# UNITED STATES PATENT AND TRADEMARK OFFICE

APPLICATION NO.	FILING DATE	FIRST NAMED INVENTOR	ATTORNEY DOCKET NO.	CONFIRMATION NO.
10/717,256	11/19/2003	Erich Schwaerzler	12761/293065	7703

<b>Office Action Summary</b>	<b>Application No.</b>	<b>Applicant(s)</b>	
	10/717,256	SCHWAERZLER ET AL.	
	<b>Examiner</b>	<b>Art Unit</b>	
	Noah C. Hawk	3637

Delmege et al., Figure 2

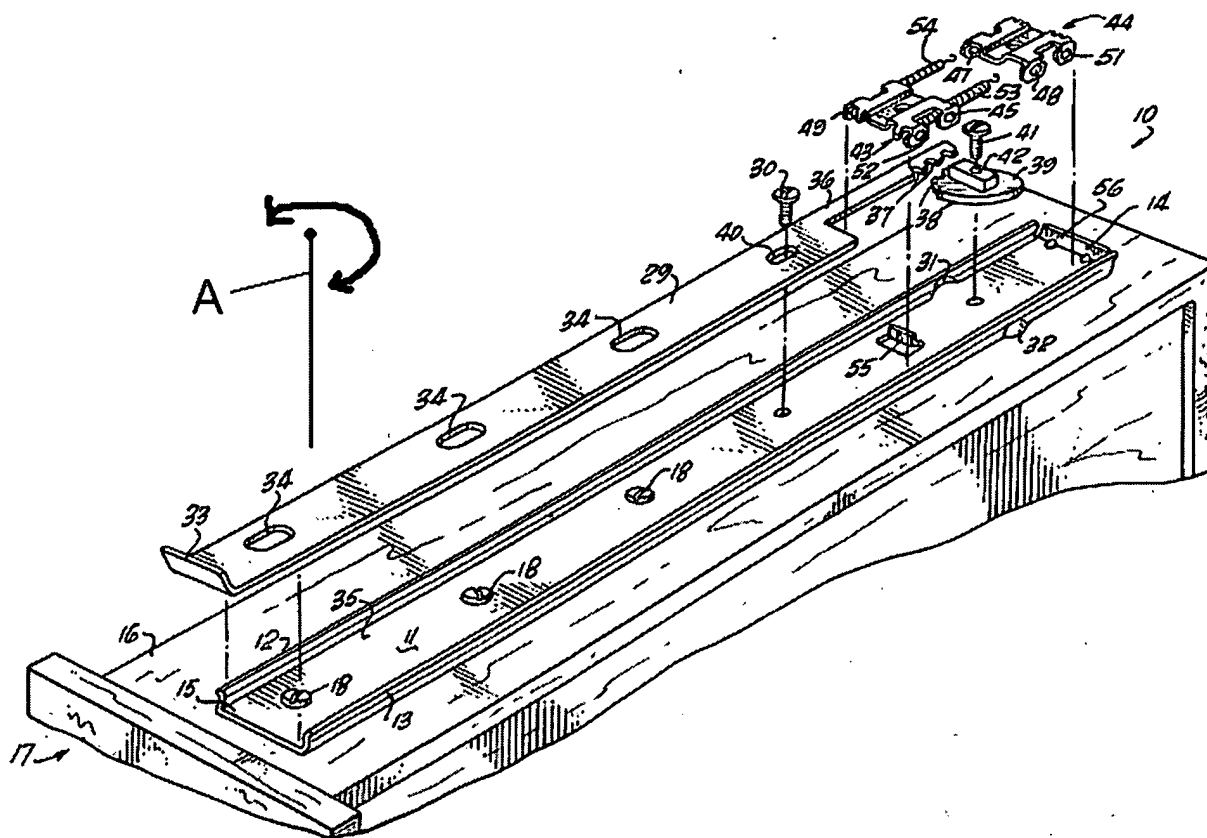
a. Regarding Claim 1, Delmege et al. disclose a panel adjustment device as structurally claimed for a drawer equipped with a front panel and located in a cabinet by means of a rail system with at least one each of a drawer rail (11) and a cabinet rail (19) which panel adjustment device is suitable for changing an enclosed inclination angle between a vertical level of a front fore side of the cabinet and a vertical level of the front panel of the drawer, the panel adjustment device comprising a lifting and lowering device (the combination of 29, 33, 36, 41, and 39) that works between the drawer and the drawer rail to swivel the drawer relative to the drawer rail about a swiveling axis, the lifting and lowering device further comprising a lifting and lowering element (39) so that a swiveling of the drawer and with it the front panel of the drawer is possible around the swiveling axis (A) and wherein the swiveling axis is disposed between the front panel of the drawer and the lifting and lowering element and a distance between the swiveling axis and the front panel is not greater than a distance between the swiveling axis and the lifting and lowering element.

- b. Regarding Claim 2, Delmege et al. further disclose a panel adjustment device wherein the swiveling axis (A) is closer to the front panel of the drawer than to the lifting and lowering element of the lifting and lowering device (best seen in Delmege et al., Figure 2).
- c. Regarding Claim 3, Delmege et al. further disclose that the swiveling axis (A) lies on the drawer rail and the lifting and lowering element (39) of the lifting and lowering device is in a rear area of the drawer on a lower compartment of the drawer (best seen in Delmege et al., Figure 1).
